# Office Action Summary

10/531,622

FOELL ET AL.

Attachment: Fig. 16 of Johnson '262

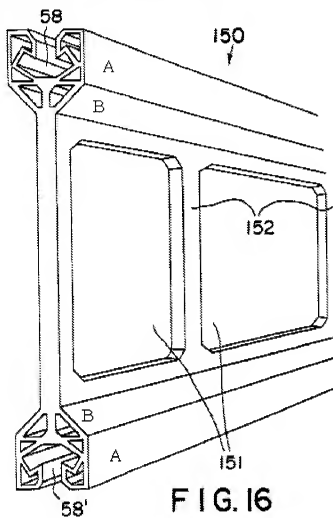
**Claims 1, 4, 6, and 8 are rejected under 35 U.S.C. 102(b) as being anticipated by Johnson '262.** Johnson discloses, Fig. 16, (see also attached annotated Fig. 16 below), an insert panel 150, wherein the insert panel has one substantially straight or flat surface and wherein the male engagement portions (surrounding 58, 58') at each end extend from a same side of the wall panel, (those engagement portions that surround 58, 58' on the same side of the panel), wherein each male engagement portion has a first projection (A) and an integral second projection (B), wherein the first projections at the ends extend substantially parallel to the wall panel and each other, and wherein the second projections at the ends extend substantially perpendicular to each other.
